CITY OF SAVANNAH

REQUEST FOR CERTIFICATE OF APPROPRIATENESS

MPC File No.: 25-006155-COA

Address: 218 West 37th Street

Previously proposed

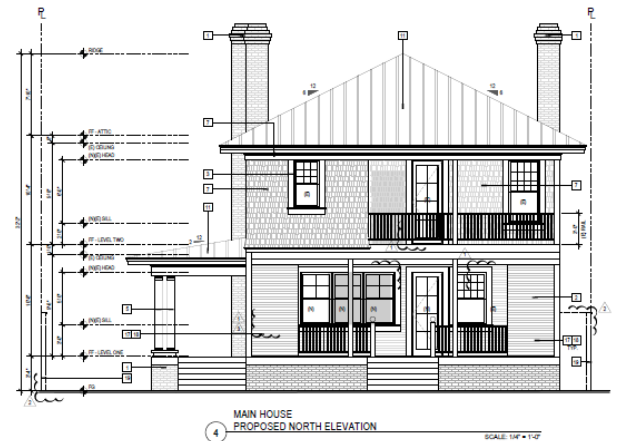
The standards are met. Much of the previously approved work remains the same and will retain the historic character of the property. The biggest difference is that the rear façade has undergone multiple alterations over time, some of which are not historically sensitive to the structure. The applicant seeks to restore a more appropriate condition to the rear. With the initial approval the condition was to remove less of the historic material and reduce the proposed four windows. In the current application this has been addressed with only three windows and retaining a portion of the wall that was initially proposed to be demolished.
